25-118ARB-MPR

ARB Submission Set Date: 12/18/25
① Revision Date: 01/14/26
② Revision Date: 01/28/26
③ Revision Date: 02/12/26

Project Title: 25-118ARB-MPR
Project Address: 20 North Street ARB Revision
Design Firm: Bass Studio Architects
Sheet Title: Cover
20 North Street Dublin, Ohio 43017

Review Elements Narrative:

3 East Elevation
Scale: 3/16"=1"

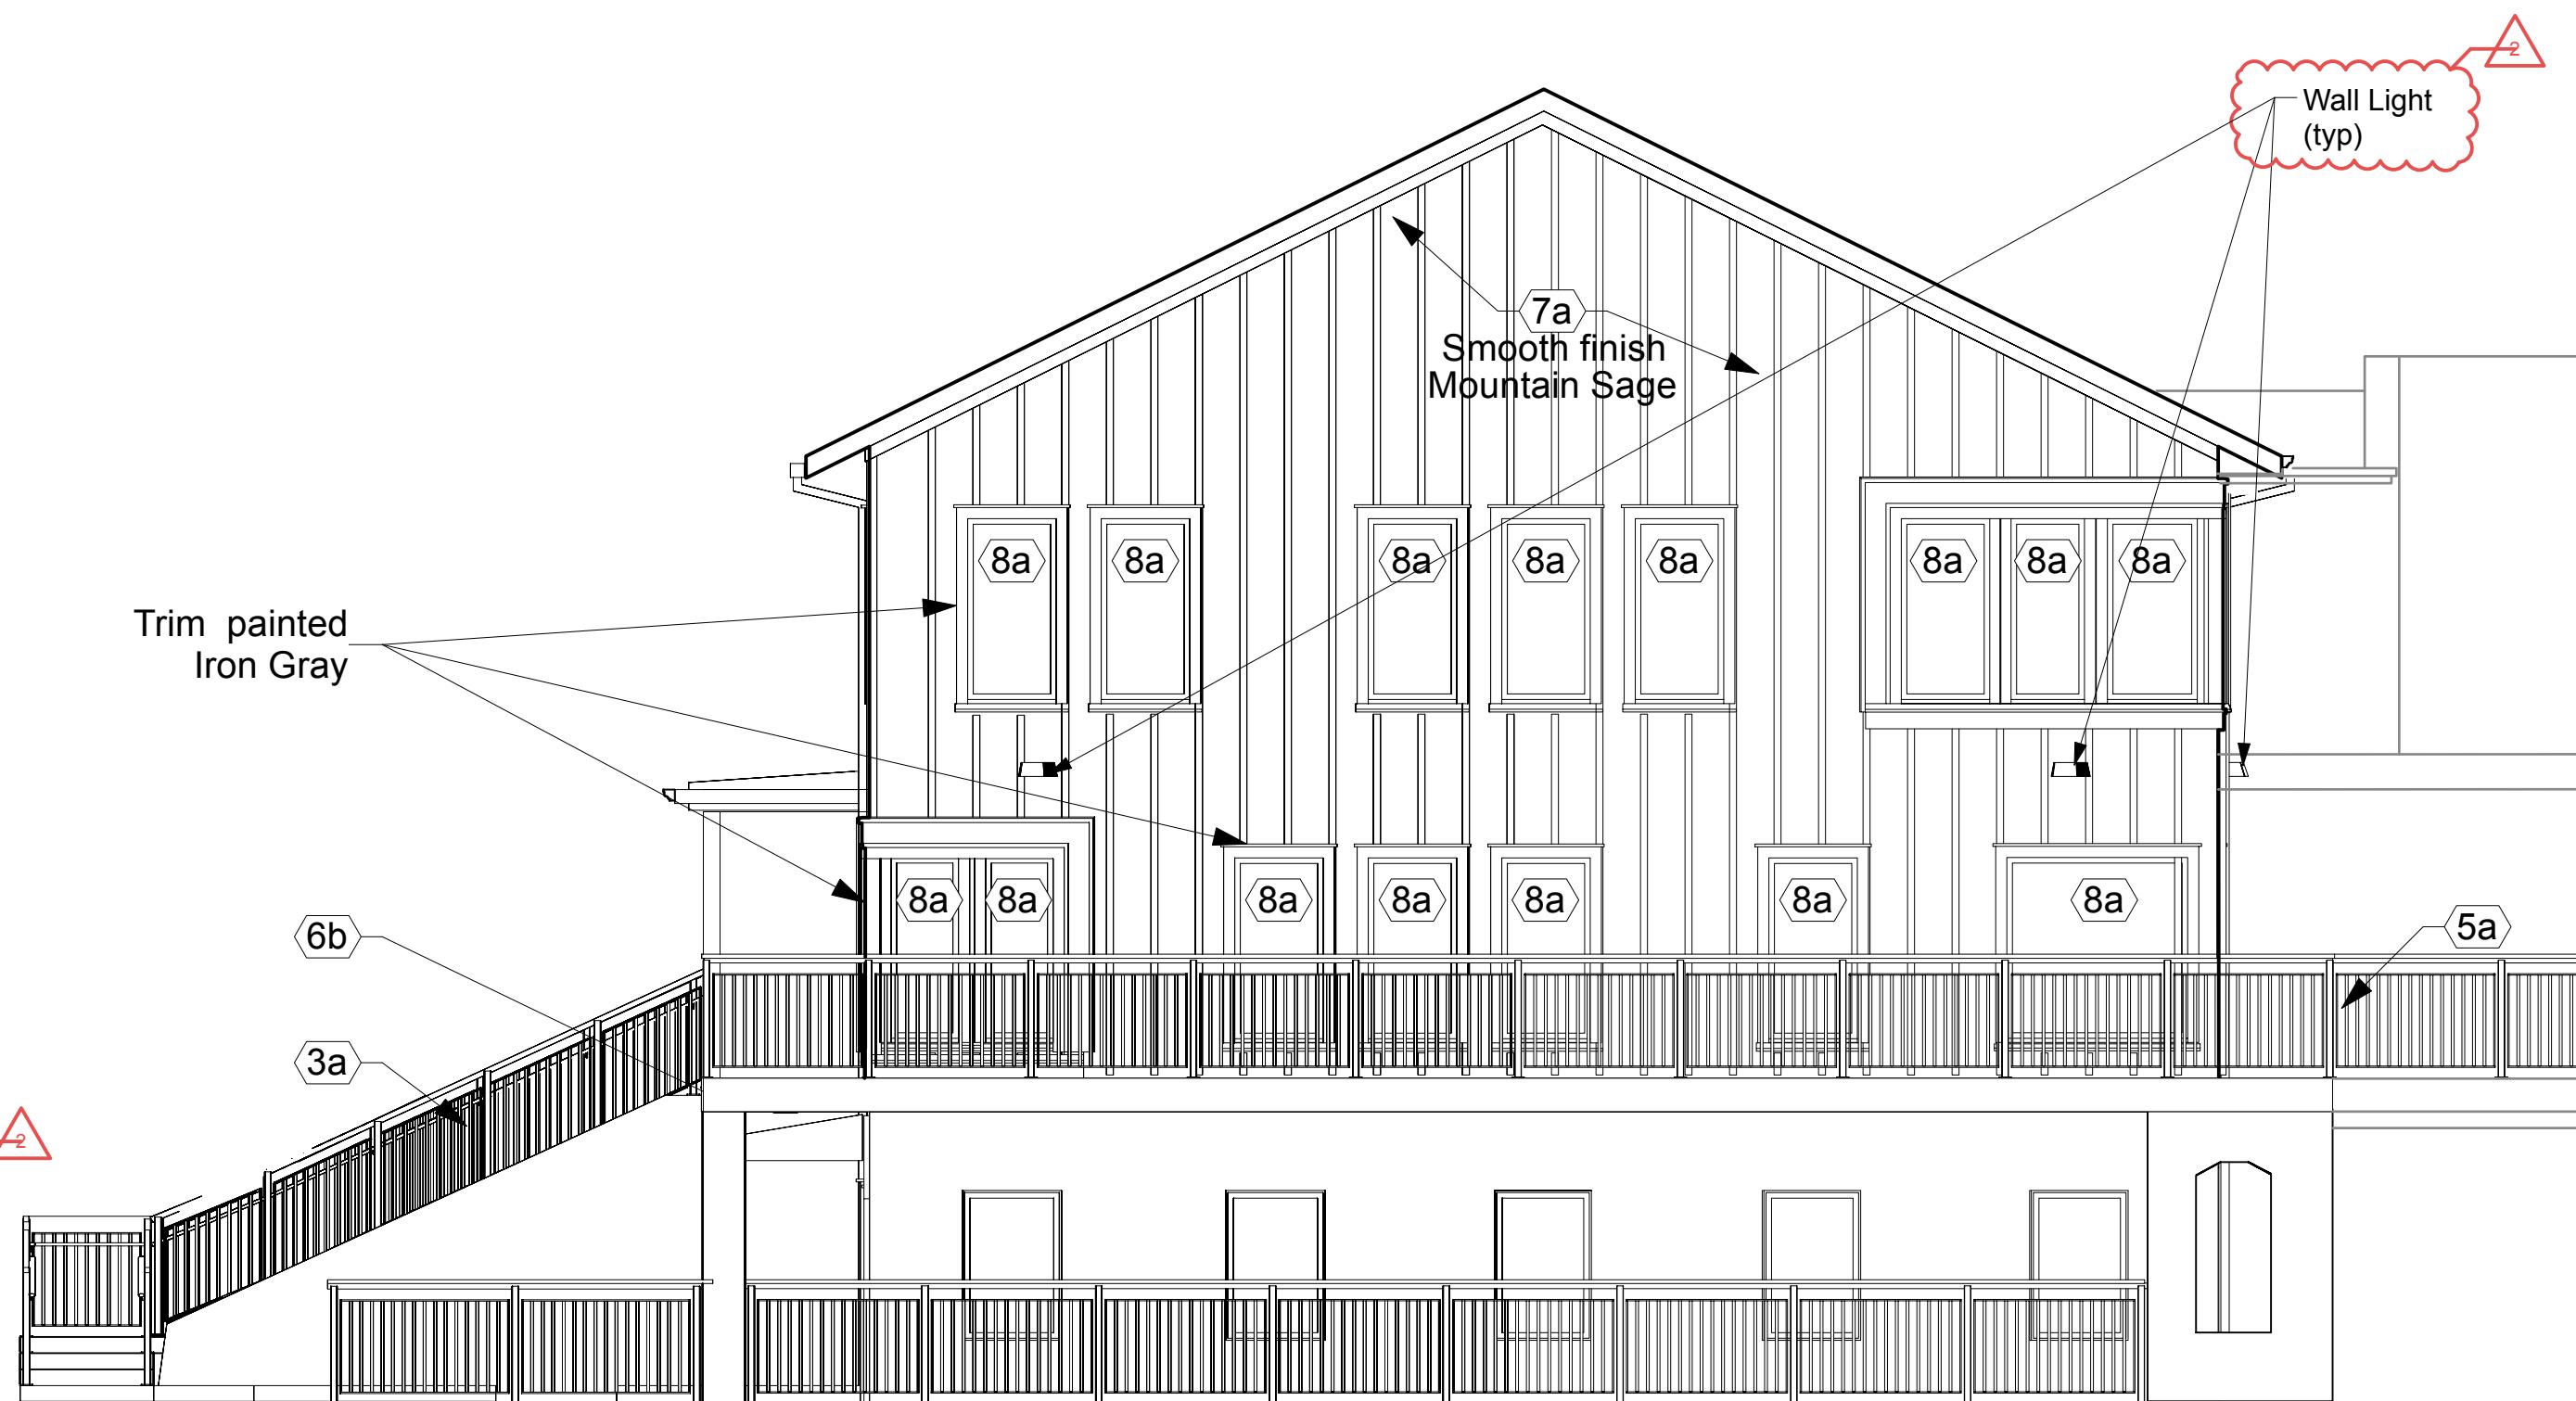
3 Site Lighting

Wall lighting was added to the east and north facades to conform this application to the engineering drawings. Please refer to the attached documents with specs and model.
